February 12, 1992
LD-92-016

Docket No. 52-002

Subject: Response to NRC Requests for Additional Information

RESPONSE TO NRC REQUESTS FOR ADDITIONAL INFORMATION
STRUCTURAL AND GEOSCIENCES BRANCH

Figure
3.7B-5

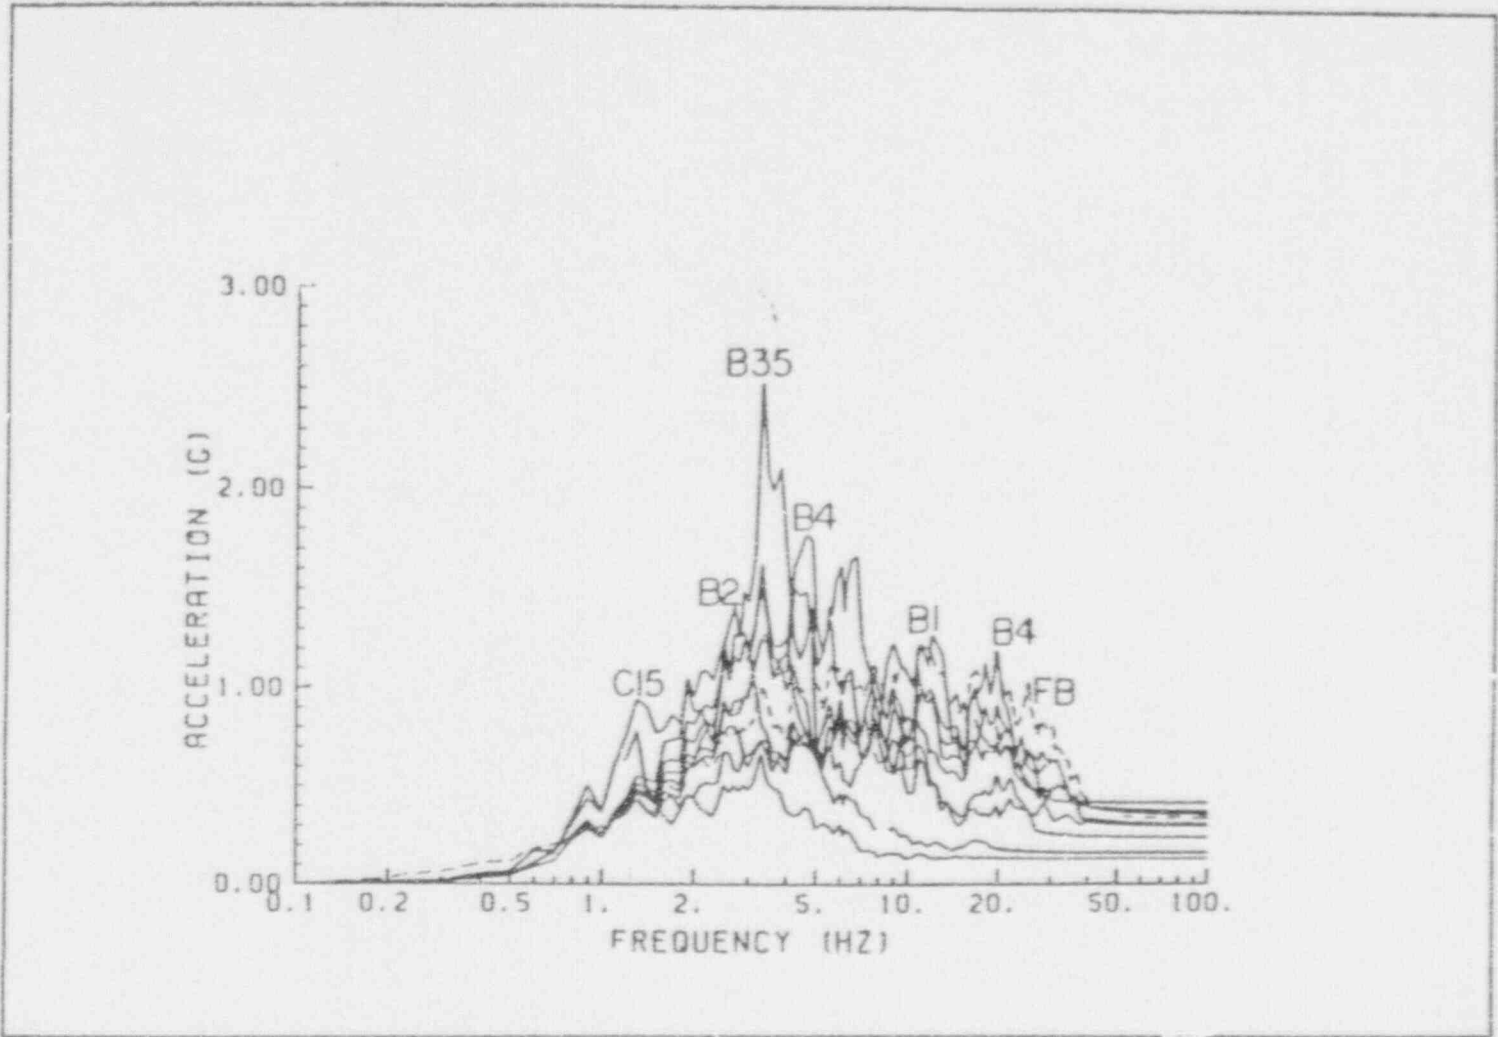
Figure 3.7B-5 has the same title as Figure 3.7B-6. Provide correct titles.

Figure 3.7B-5 should read "(..., 0°-180° direction)", not "(..., vertical direction)". The Figure 3.7B-6 title is correct.

The title to Figure 3.7B-5 will be corrected in a future amendment to CESSAR-DC.

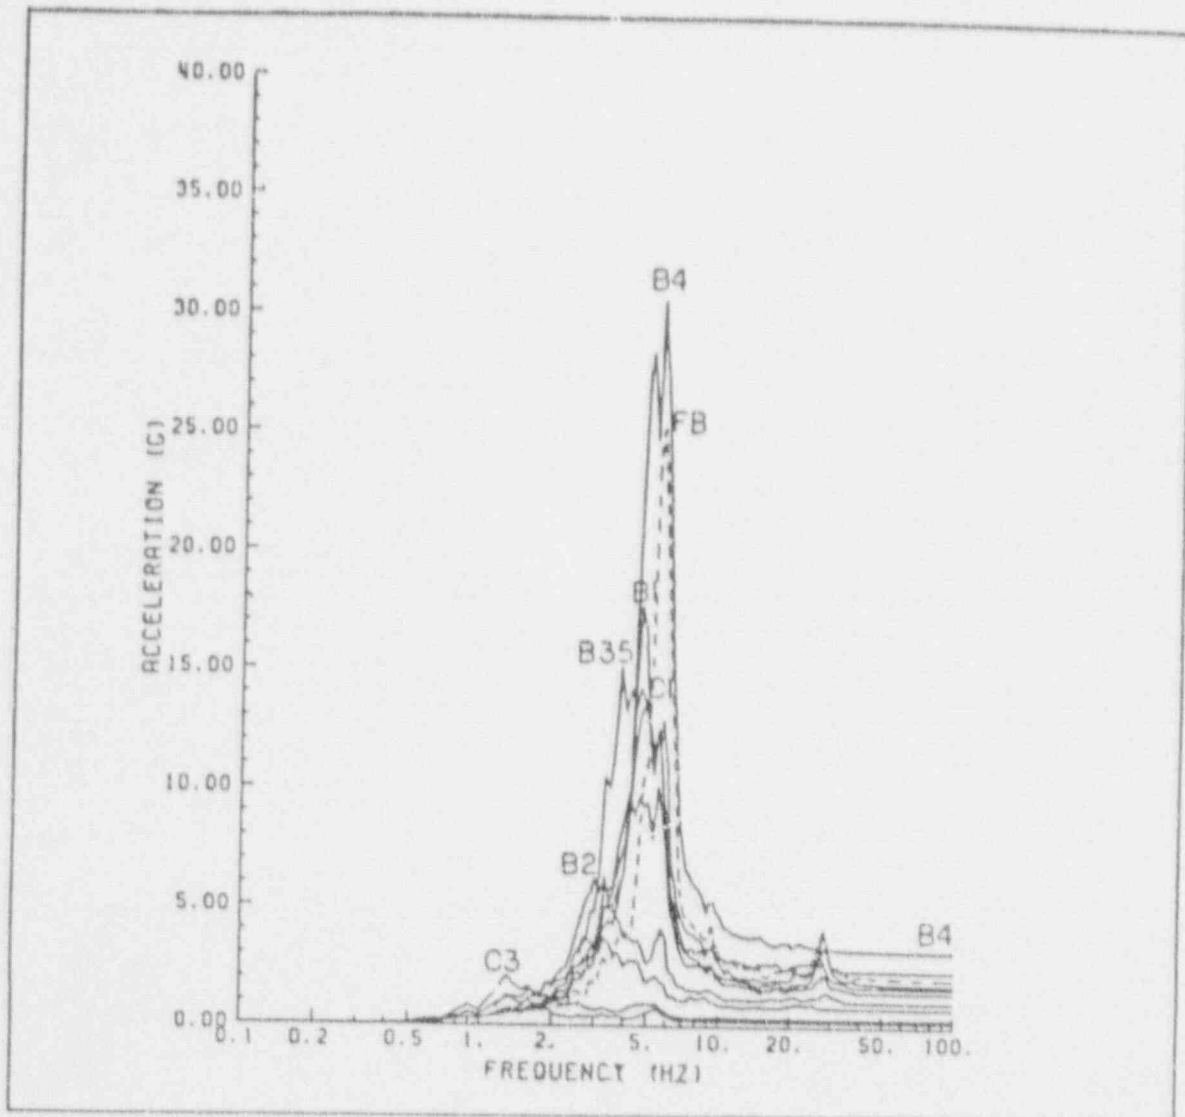
The Figure 3.7B-11 title should read "(... , 0-180 Direction)", not "(... , vertical direction)". The title for Figure 3.7B-12 is correct.

The Figure 3.7B-11 title should read "(... , 0°-180° Direction)", not "(... , Vertical Direction)". The title for Figure 3.7B-12 is correct. The title to Figure 3.7B-11 will be corrected in a future amendment to CESSAR-DC.

Fig. 1 Range of Modulus Reduction Curves for Clays and for Sands

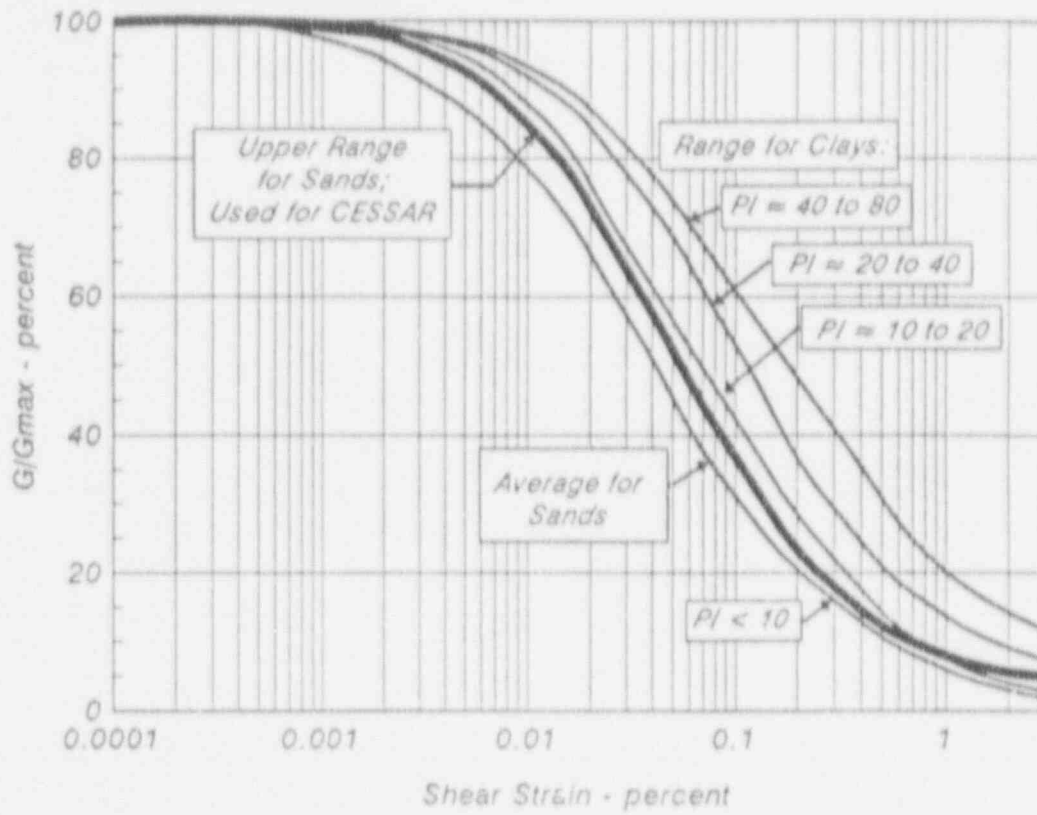
Section 2.5.2.5.2 - Why are the upper bounds (non-conservative) of the shear modulus shear strain relationship (Figure 2.5-3) published by Seed and Idriss selected?

Available modulus reduction curves for cohesionless as well as cohesive soils are presented in Figure 1; the term PI shown in Figure 1 is the plasticity index. Note that the lower range of the modulus reduction curve originally published by Seed and Idriss (1970) is not shown in Figure 1 and that the curve labeled $PI < 10$ is approximately equal to the average modulus reduction curve published by Seed and Idriss for sands.

FINITE ELEMENT MODEL STEEL CONTAINMENT VESSEL

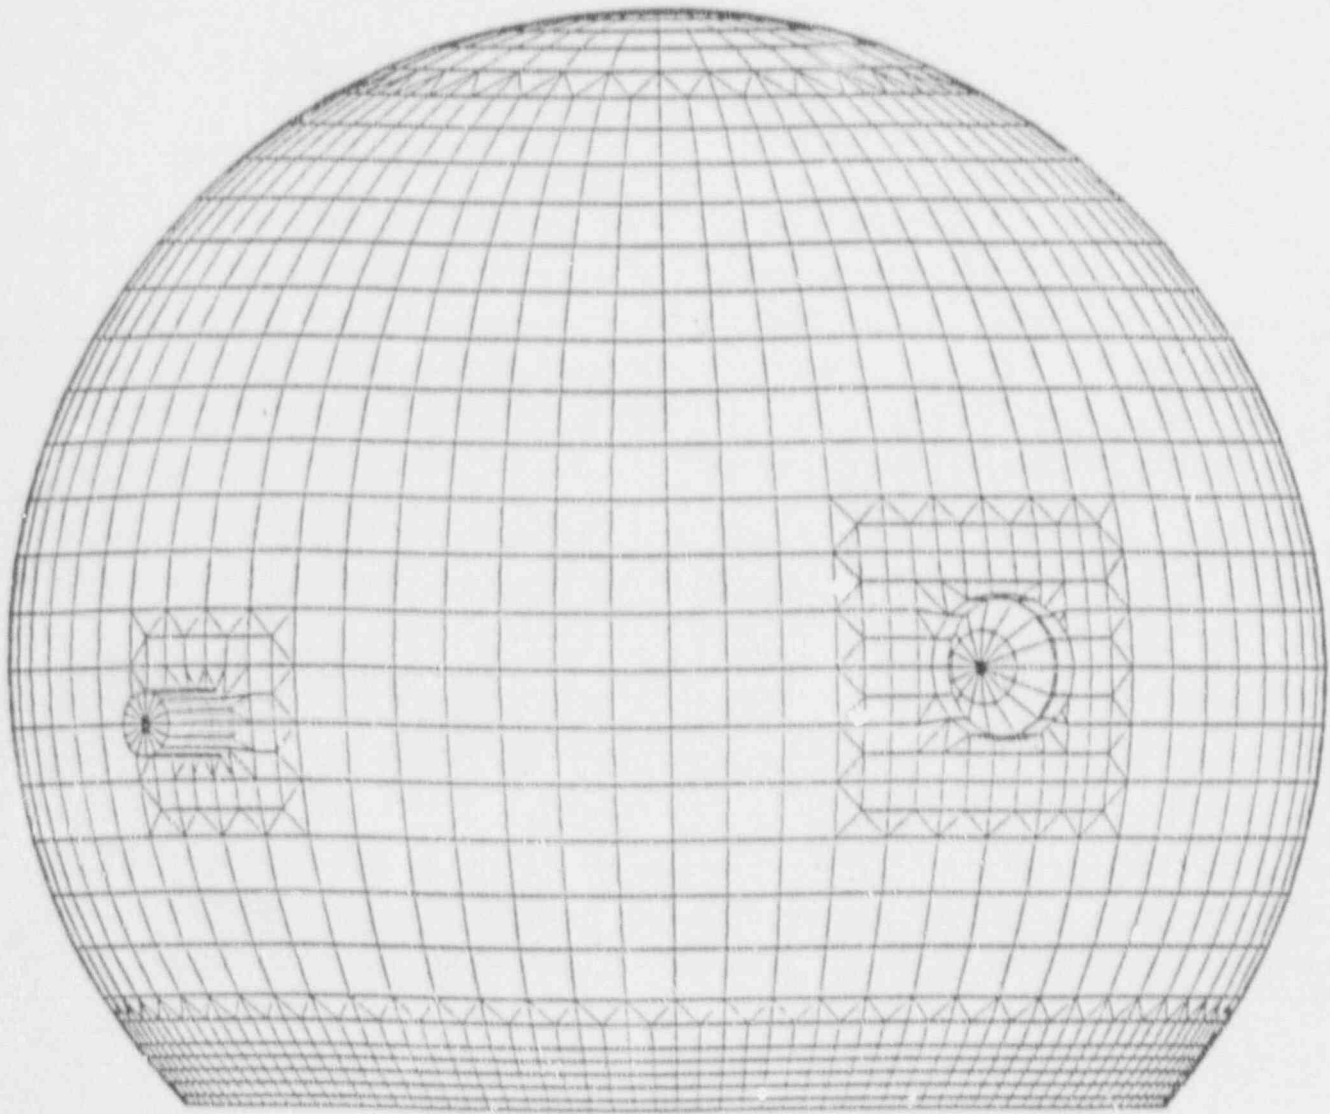
Section 3.8.2.1.2 - One of the highly stressed regions of the containment shell under seismic and thermal conditions is in or near the transition region (Sheet 3 of 3, Figure 3.8-1). Provide quantitative information to show that buckling and over-stress will not occur in this region.
